CITY OF ALBUQUERQUE

Re: Broadway Cultivation Facility
1340 Broadway Blvd. NE
Traffic Circulation Layout
Architect's Stamp 06-15-22 (J14-D202)

Based upon the information provided in your submittal received 08-19-22, the above referenced plan cannot be approved for Building Permit until the following comments are addressed:

B3 H.C. RAMP DETAILS
Scale: 1/4" = 1'-0"

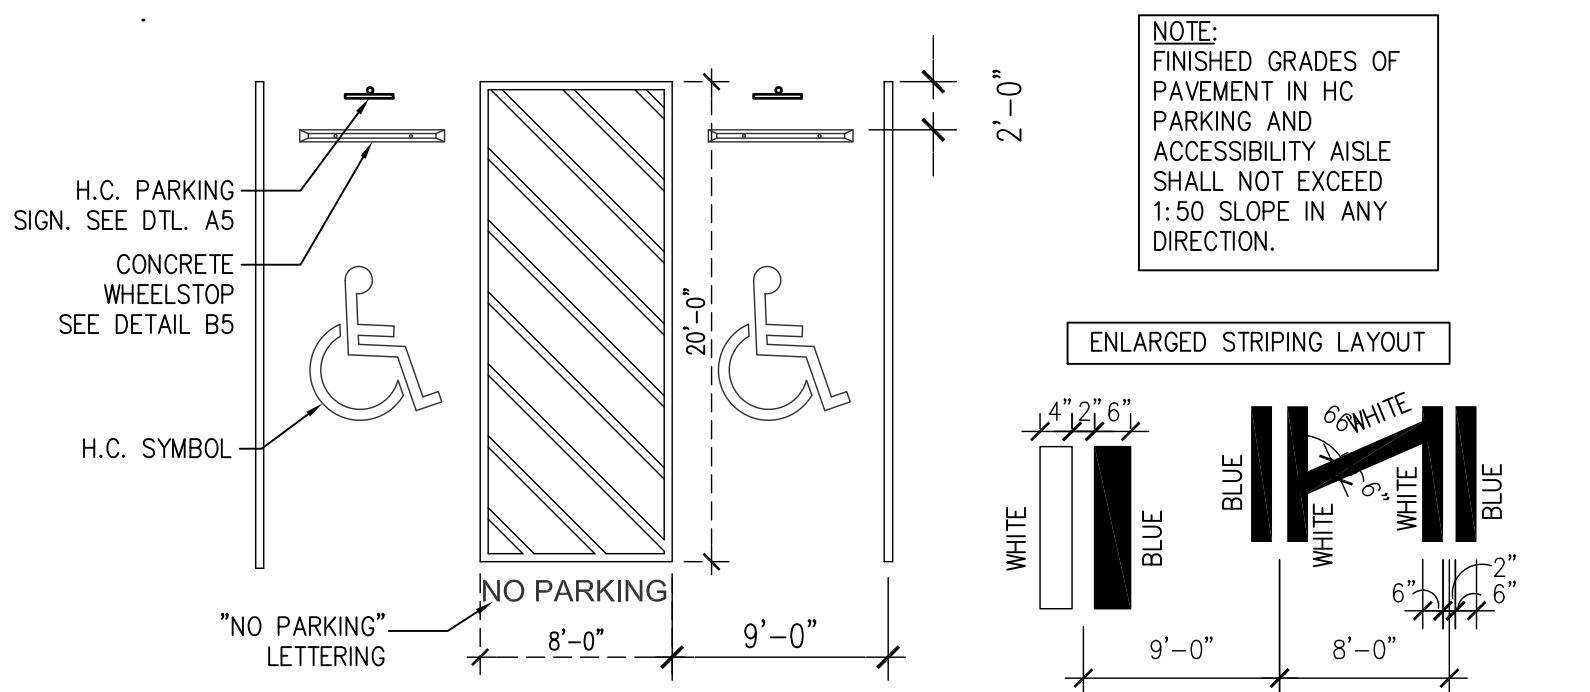
6. ADA Ramp at the corner of Broadway Blvd. and Kinley Ave. need to be updated to current COA standard.
7. ADA curb ramps must be updated to current standards and have truncated domes installed.

A1 SITE PLAN
Scale: 1" = 10'

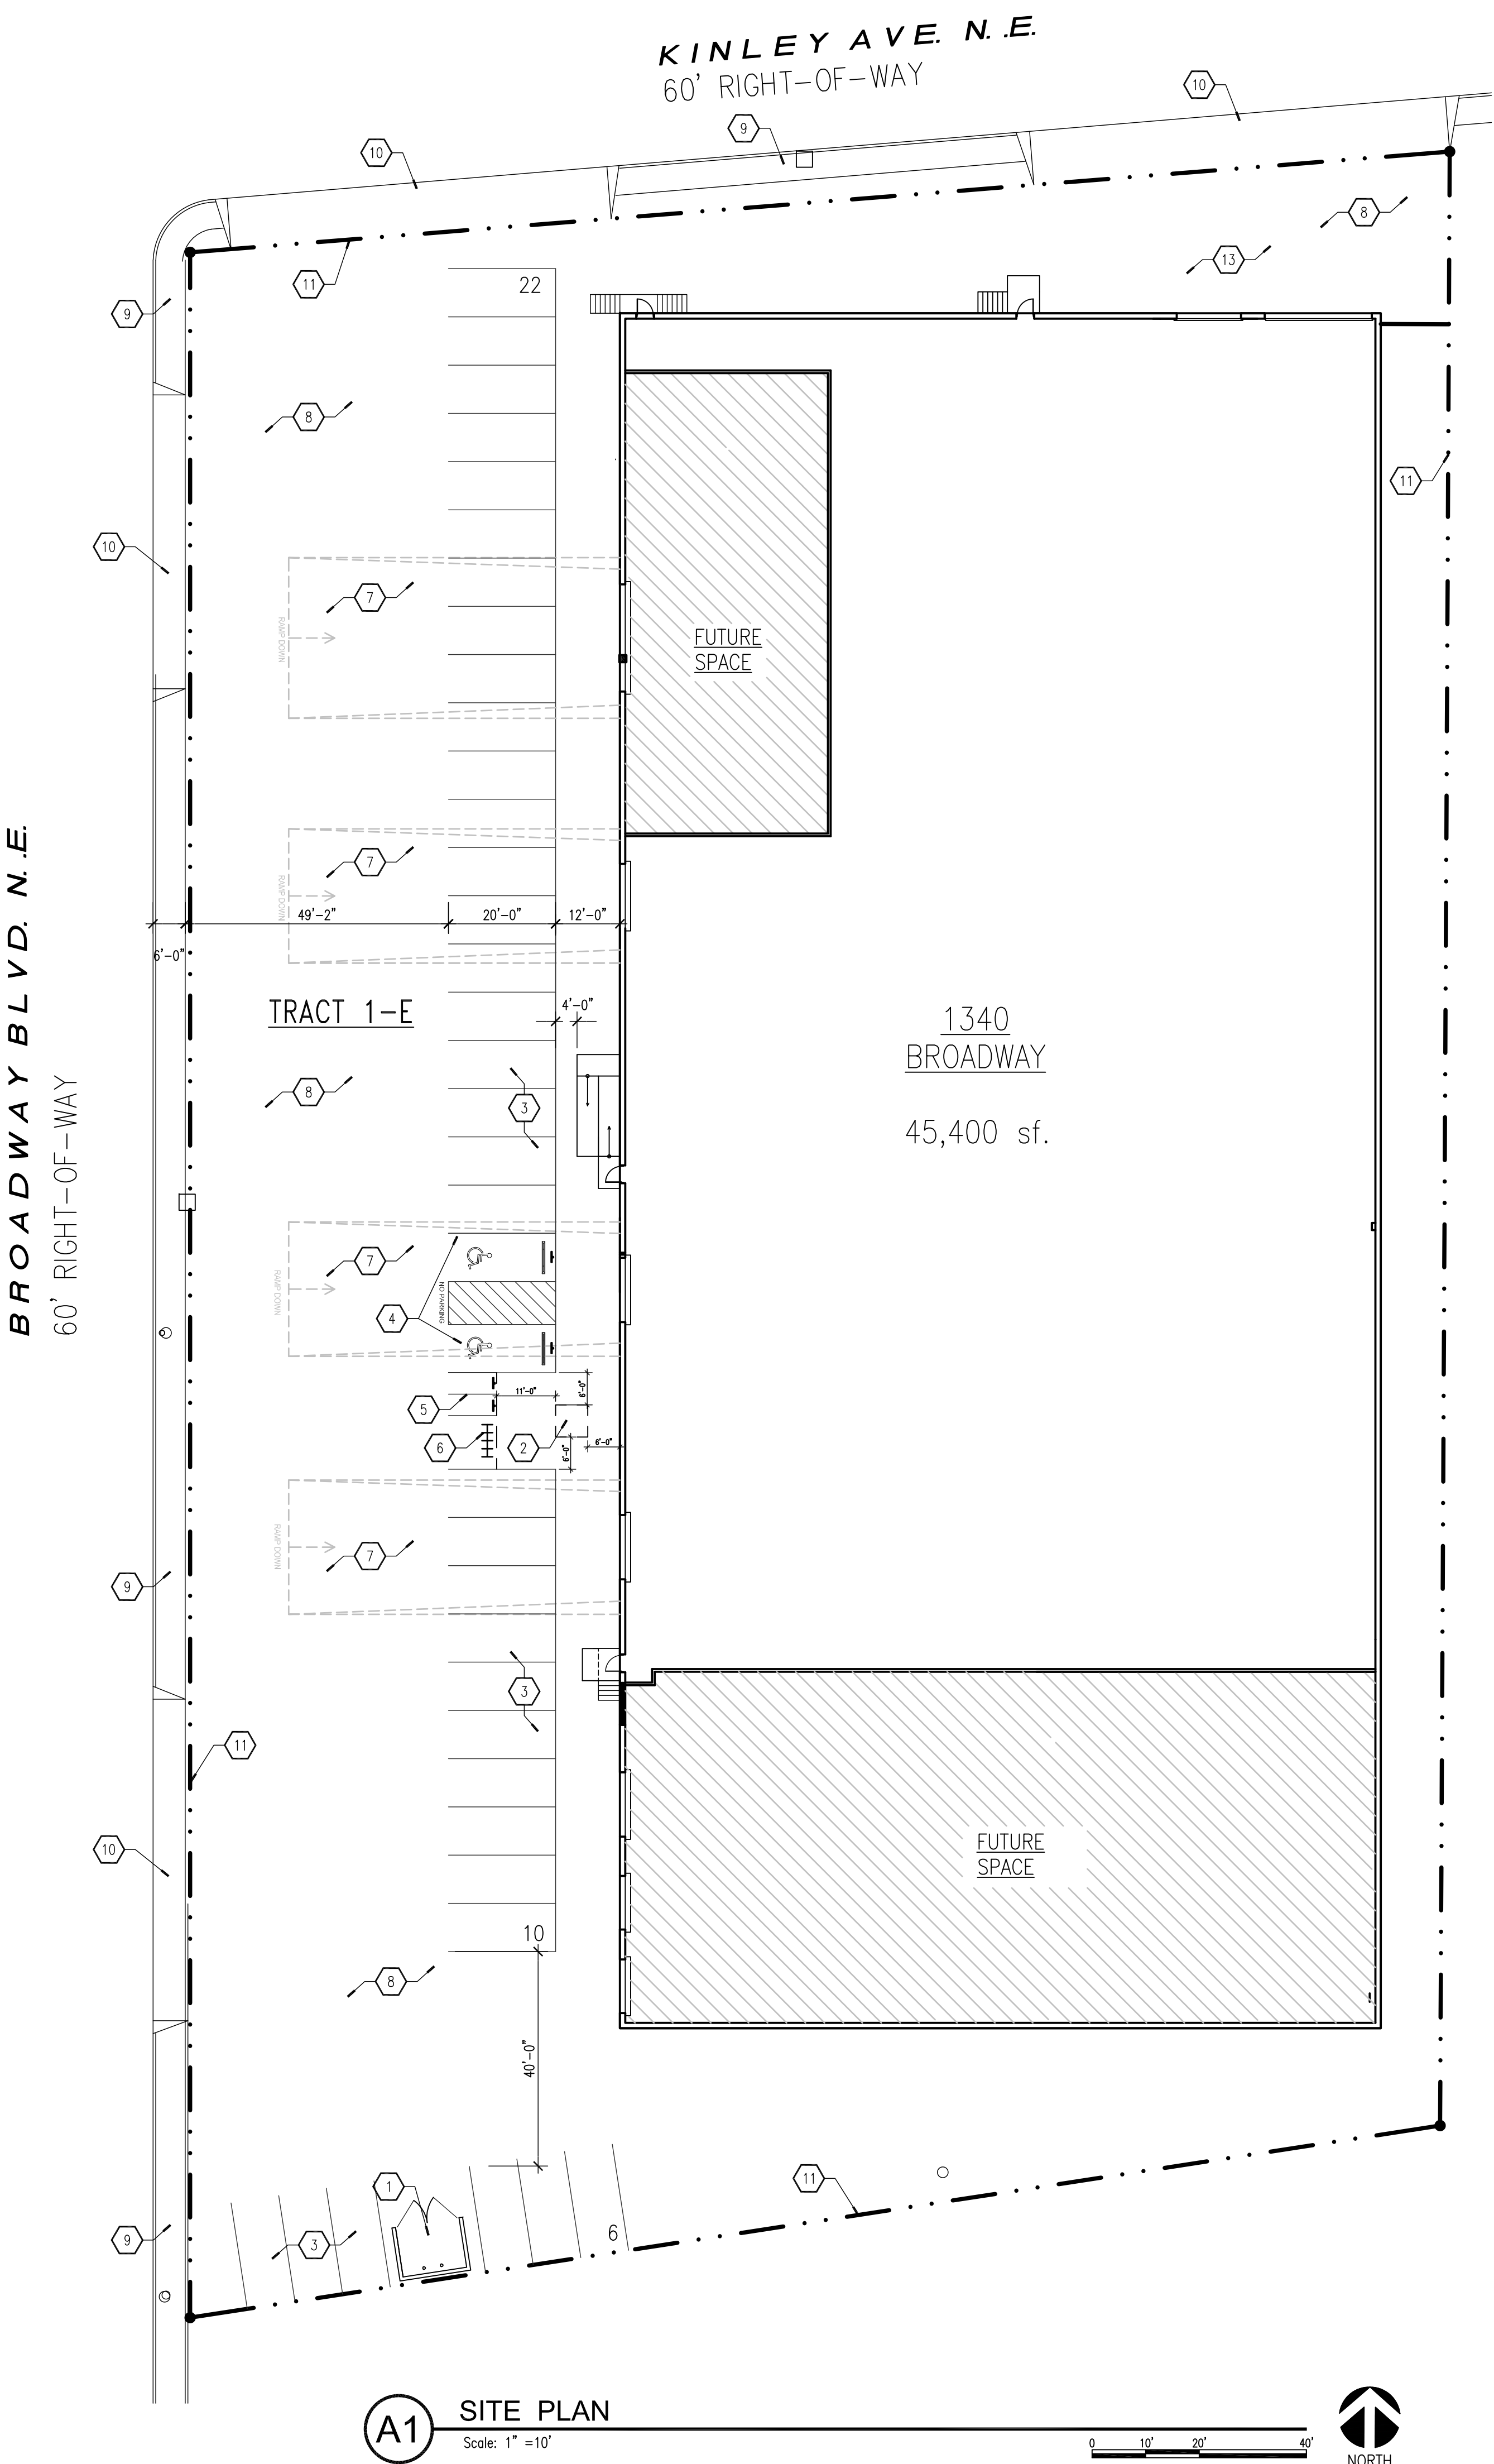
1. Please see attached Minimum Distance from Commercial Site Access Points to the Intersection. Also, note that Broadway Blvd. is classified as Principal Arterial, and Kinley Ave. classified as Local St.
2. Curb Return Access design need to provided.
3. Maximum access width for arterial, collector, and local streets are as follows:

4. Please list the width and length for all existing and proposed parking spaces. Some dimensions are not shown.
5. The minimum parking stall dimensions are:

8. Motorcycle parking spaces shall be designated by its own conspicuously posted upright sign, either free-standing or wall mounted per the zoning code. Please provide signs details.

9. The pavement marking "MC" should be shown in the opposite direction for motorcycles entering the parking space.
10. All bicycle racks shall be designed according to the following guidelines:

14. Per the IDO, a 6 ft. wide ADA accessible pedestrian pathway is required from the public sidewalk to the building entrances. Please clearly show this pathway and provide details.

15. Per DPM, a 6 ft. wide ADA accessible pedestrian pathway is required from the ADA parking stall access aisles to the building entrances. Please clearly show this pathway and provide details.

16. ADA accessible pedestrian pathway should not be placed behind parking space or adjacent to a vehicular way. Vehicle and pedestrian/wheel chair conflicts should be avoided as much as possible.

17. Parking areas shall have barriers to prevent vehicles from extending over public sidewalk, public right-of-way, or abutting lots. Provide details for the barriers curb.

18. Refuse vehicle maneuvering shall be contained on-site. The refuse vehicle shall not back into the public right of way. provide a copy of refuse approval.

19. Please provide a sight distance exhibit
20. Show the clear Intersection sight distance and add the following note to the plan:
"Landscaping and signage will not interfere with clear sight requirements. Therefore,

signs, walls, trees, and shrubbery between 3 and 8 feet tall (as measured from the gutter pan) will not be acceptable in the clear sight triangle. See attached

21. Please specify the City Standard Drawing Number when applicable.
22. Unused curb cuts must be replaced with sidewalk and curb & gutter. A build note must be provided referring to the appropriate City Standard drawing.
23. Add a note stating "All broken or cracked sidewalk must be replaced with sidewalk and curb & gutter." A build note must be provided referring to the appropriate City Standard drawing.
24. Please provide a letter of response for all comments given.
25. Traffic Studies: See the Traffic Impact Study (TIS) thresholds. In general, a minimum combination of 100 vehicles entering and exiting in the peak hour warrants a Traffic Impact Study. Visit with Traffic Engineer for determination, and fill out a TIS Form that states whether one is warranted. In some cases, a trip generation may be requested for determination (**Contact Matt Grush: mgrush@cabq.gov**).
